AGENDA
BUDGET & FINANCE COMMITTEE MEETING
Tuesday, August 10, 2021 at 7:00 p.m.
N168 W20733 Main Street
Jackson, WI 53037

SECTION 00 63 63 CHANGE ORDER

Change Order No. 9

JACKSON MUNICIPAL COMPLEX
MAIN ENTRANCE - REVISION TO
LIT BOLLARD LOCATIONS

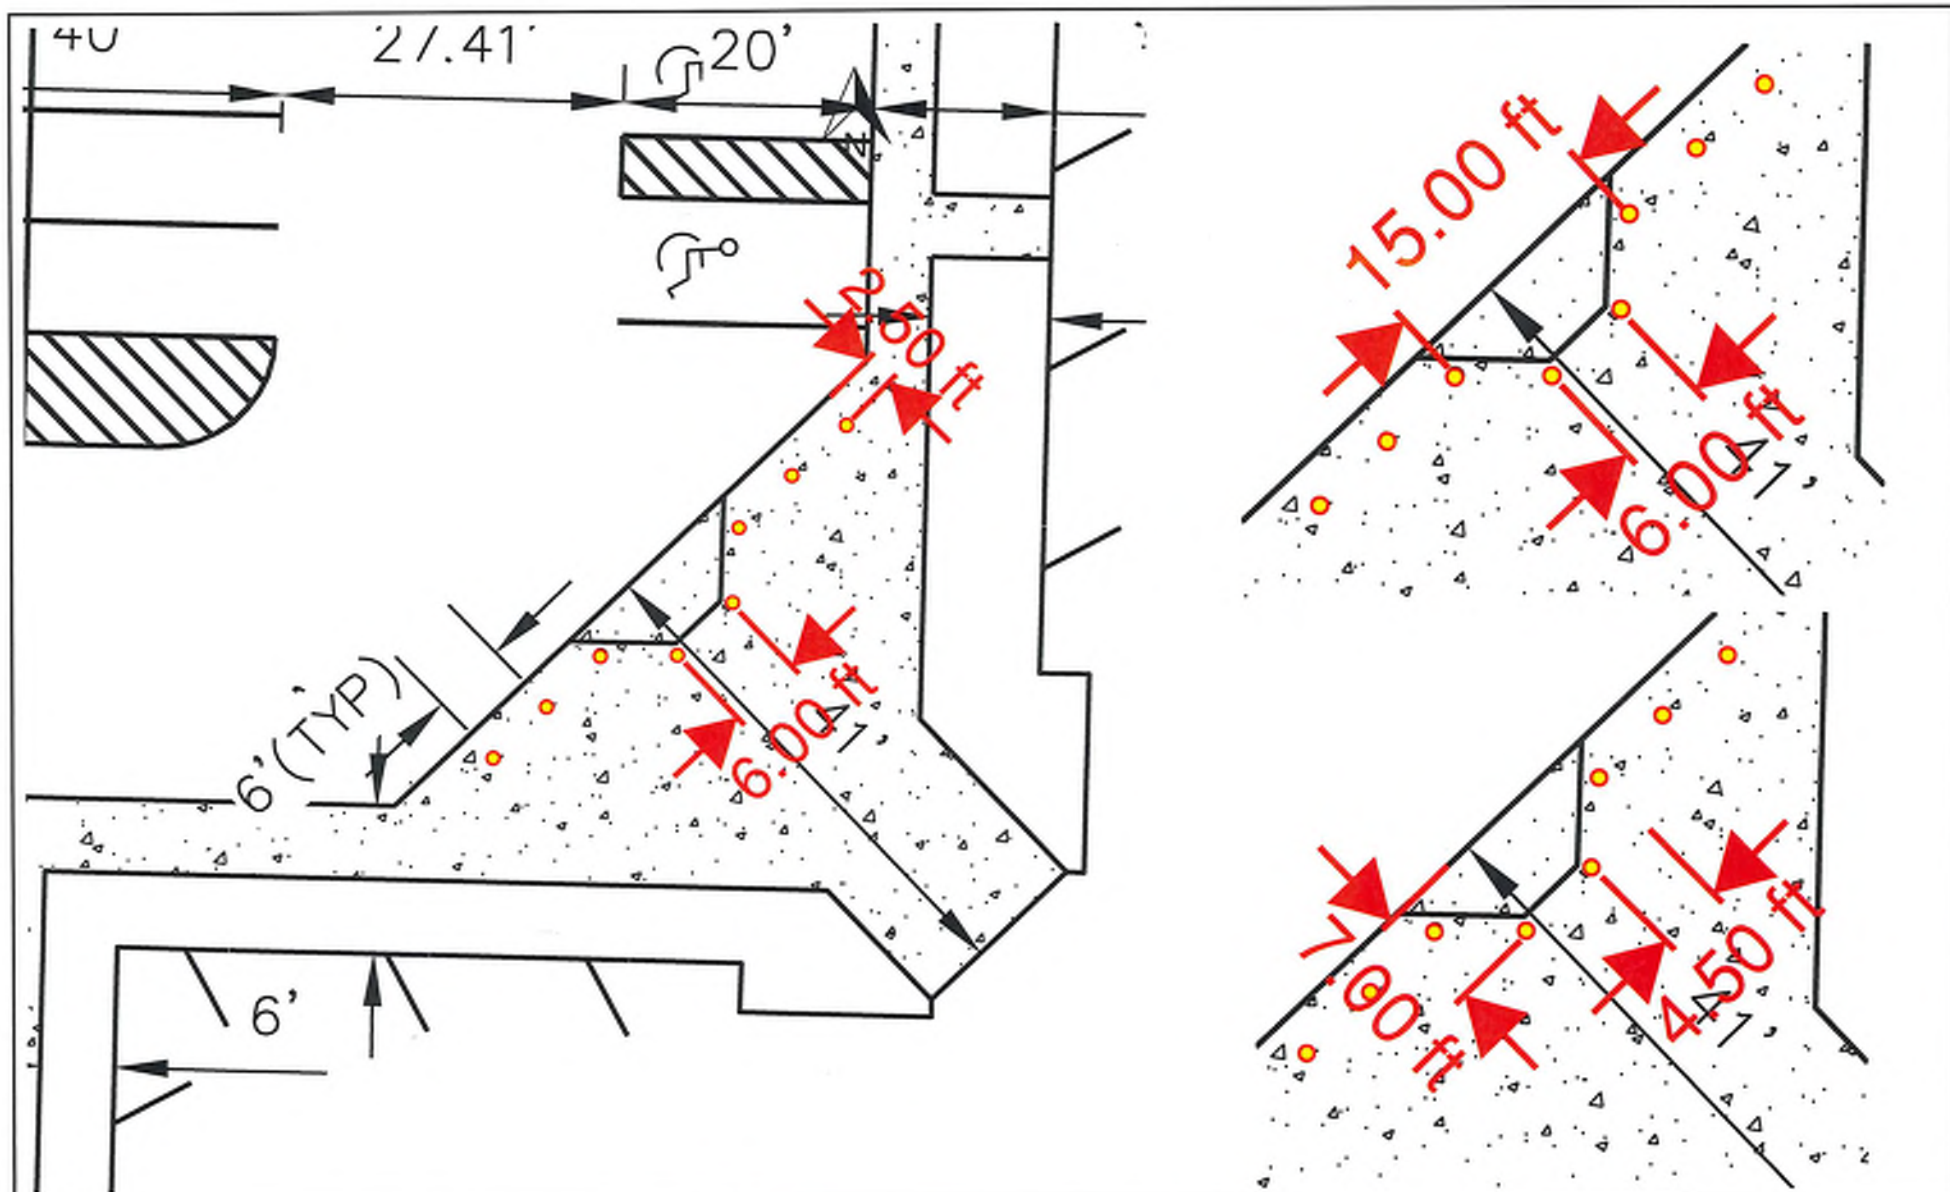
Revision to amount of proposed security bollards fronting the main building entrance. Bollard locations were revised from within the asphalt pavement section to within the concrete sidewalk section which reduced the number of bollard required from 9 each to 8 each.

- 1) Reduce number of bollards **from** proposed nine (9) **to** revised eight (8).
- 2) Revise bollard locations **from** within HMA pavement **to** within concrete sidewalk: 2.5' from face of curb.
- 3) Revise bollard alignment as shown on attached exhibit.

DRAWING SHEET REF: ES100

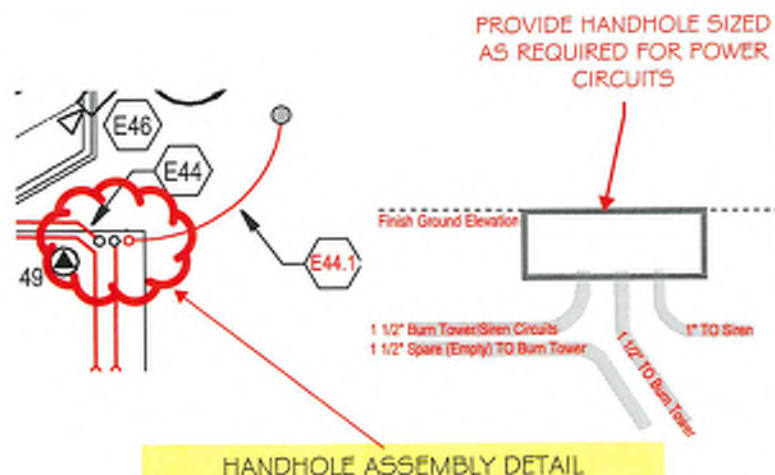
Please provide a cost proposal related to the addition of Tornado Siren Circuit Wiring within the previously designated conduits (see attached) as follows:

- Provide cabling from the 20 amp circuit breaker to the conduit at the pole. At that location, provide a 10 foot coil of cable so the Siren vendor can extend the cable to the control cabinet about 6 feet above the finish grade.

ENLARGED FIRST
FLOOR SYSTEM
PLAN "C"

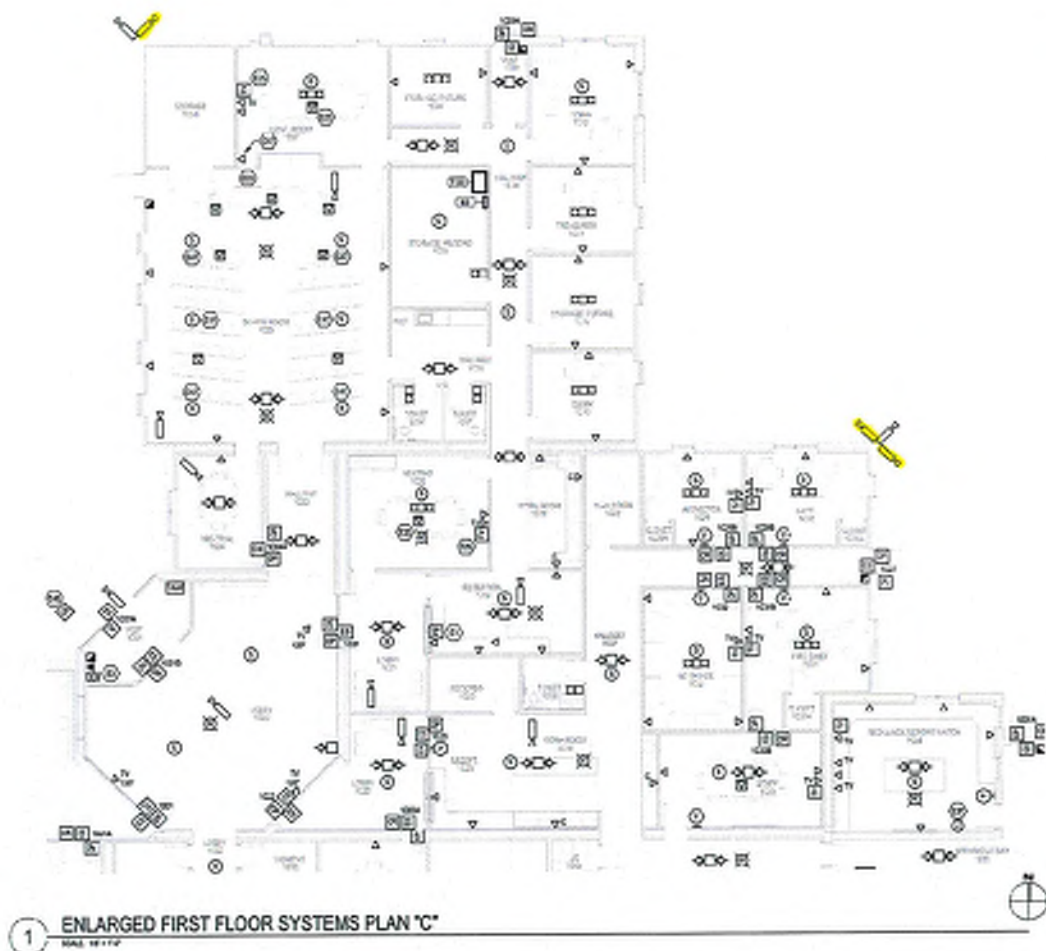
- Provide (8) CAT6 cable runs to the added security camera locations shown and highlighted on the attached plans to SEC/IT 1B05 room. Terminate and test cabling per Contract Documents.

AREA 1

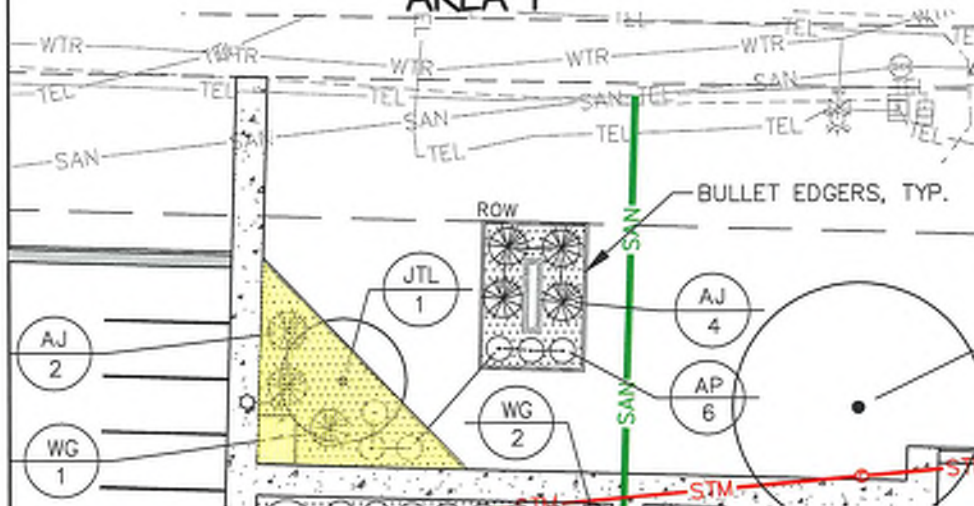
DELETE:

545 sf Planting Bed Preparation
 545 sf Geotextile Fabric Weed Barrier
 545 sf Stone Mulch
 50 lf Bullet Edgers

AREA 2

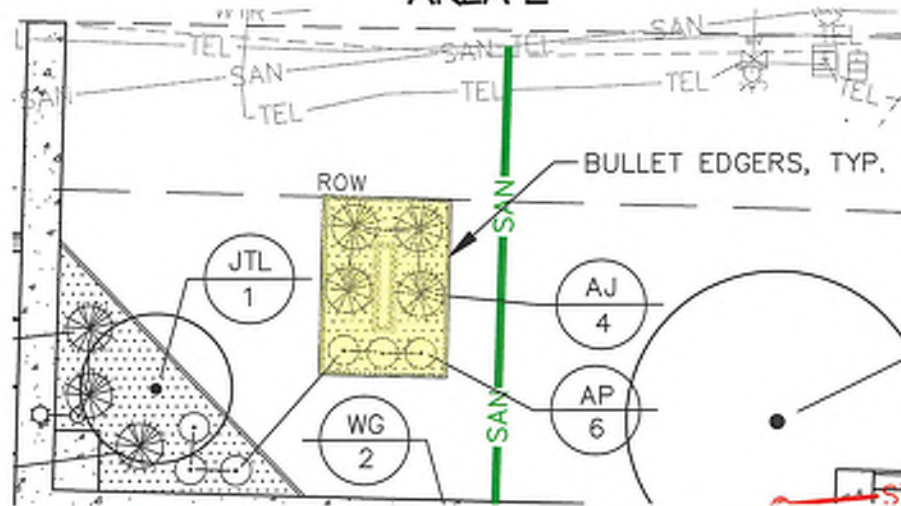
DELETE:

396 sf Planting Bed Preparation
 396 sf Geotextile Fabric Weed Barrier
 396 sf Stone Mulch
 80 lf Bullet Edgers
